**STAFF RECOMMENDATION**  
**1811 Beechwood Avenue**  
**June 16, 2021**

**Application:** New Construction—DADU (Revision to Previously Approved Plan)  
**District:** Belmont-Hillsboro Neighborhood Conservation Zoning Overlay  
**Council District:** 18  
**Base Zoning:** RS7.5  
**Map and Parcel Number:** 10416025300  
**Applicant:** Martin Wieck, Nine12 Architects  
**Project Lead:** Melissa Sajid, [Melissa.sajid@nashville.gov](mailto:Melissa.sajid@nashville.gov)

**Description of Project:** Application is to construct a detached accessory dwelling unit that is located less than twenty feet (20') from the primary structure due to a stormwater easement. This is a revision to a DADU approved by the Commission in August 2020 (HCP 2020048999).

1
**ARCHITECTURAL SITE PLAN**  
SCALE: 1/16"=1'-0"

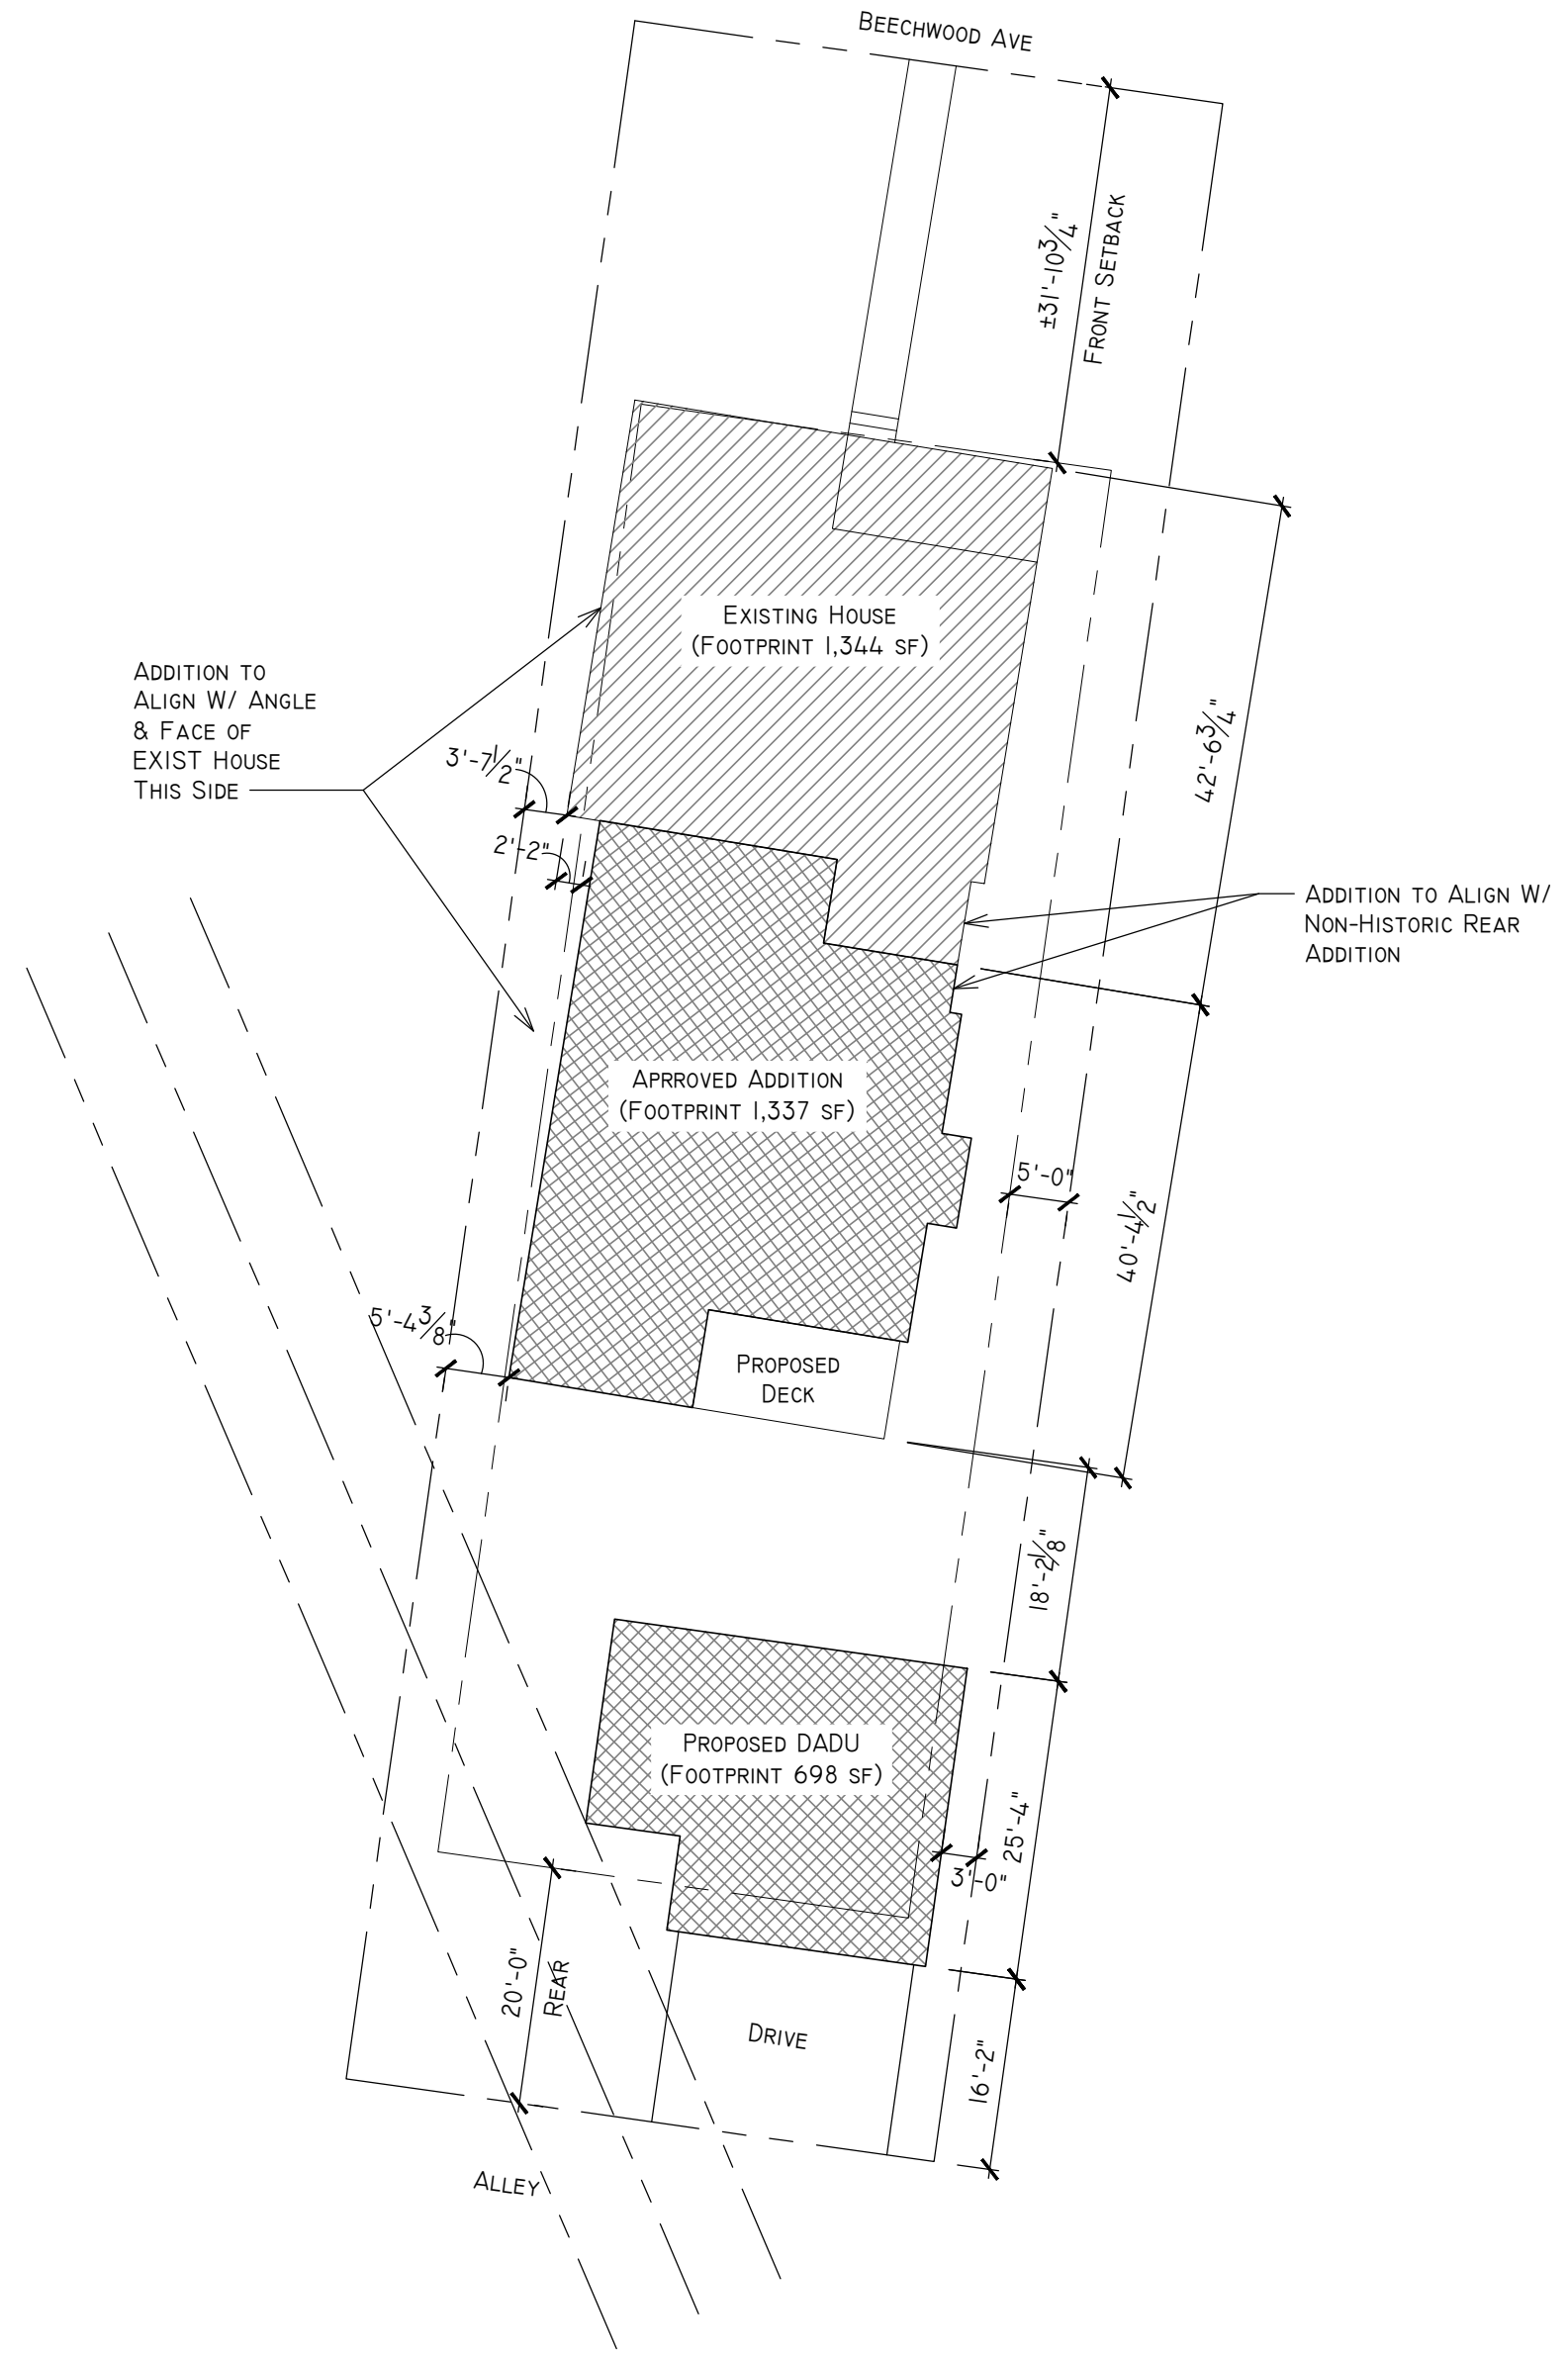
The proposed DADU is located approximately eighteen feet, two inches (18'-2") from the rear of the approved addition. While the design guidelines require a separation of at least twenty feet (20'), staff finds that the proposed location can be appropriate in this

case given the fifteen feet (15') wide stormwater easement that crosses the right rear corner of the property. In addition, the applicant has reduced the footprint by fifty-two square feet (52 sq. ft.) from the previous approval.

**Recommendation:** Staff recommends approval with the condition that all materials for the DADU be approved prior to purchase and installation. With this condition, staff finds that the project meets Section II.B of the *Belmont-Hillsboro Neighborhood Conservation District: Handbook and Design Guidelines*.

DADU FLOOR  
PLANS

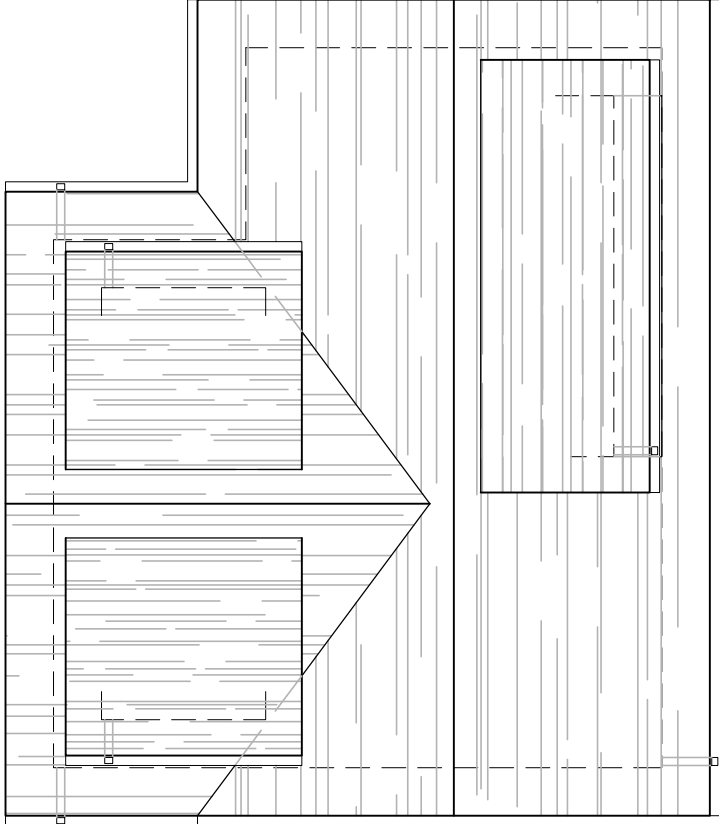
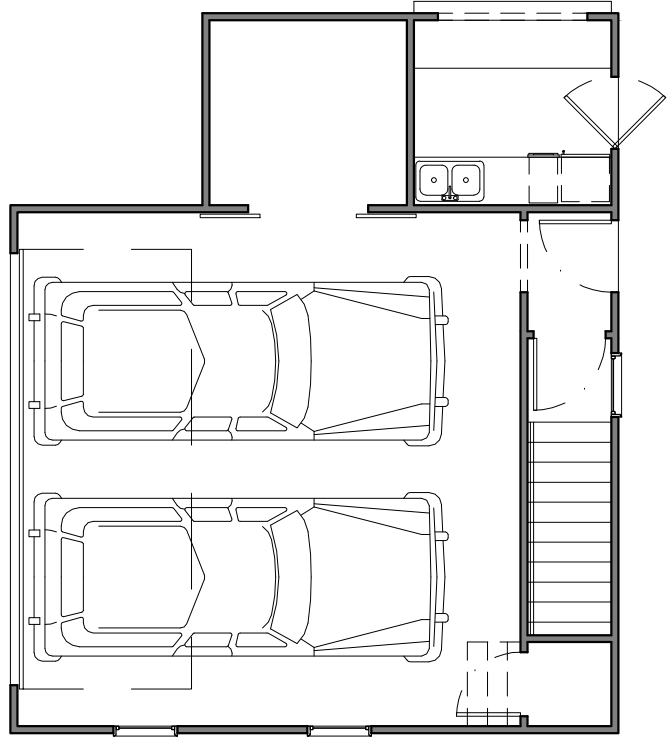
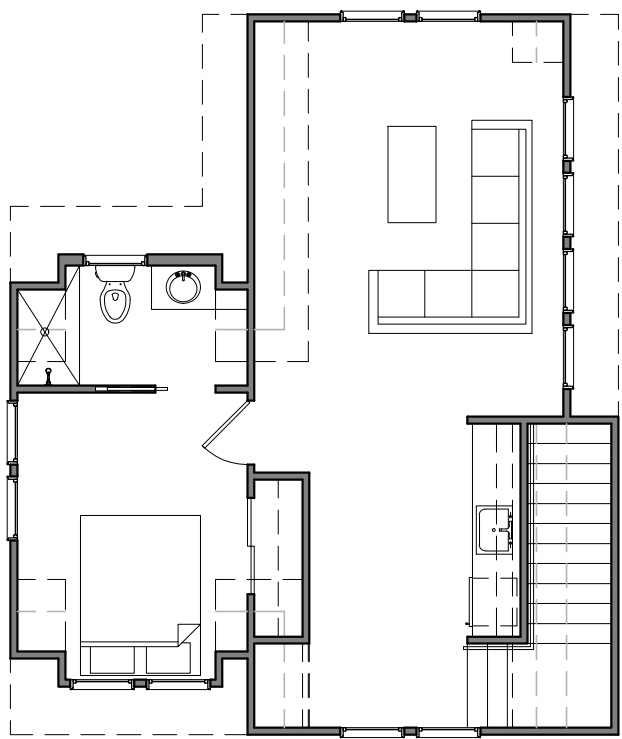
Proposed Element	Proposed DADU	Typical of district?
Primary form	Cross-gable	Yes
Primary roof slope	~ 14/12	Yes
Dormer form	Shed	Yes
Dormer roof slope	~ 4/12	Yes

Staff finds that the proposal meets Section II.B.1.i of the design guidelines for roof shape and meets the DADU ordinance.
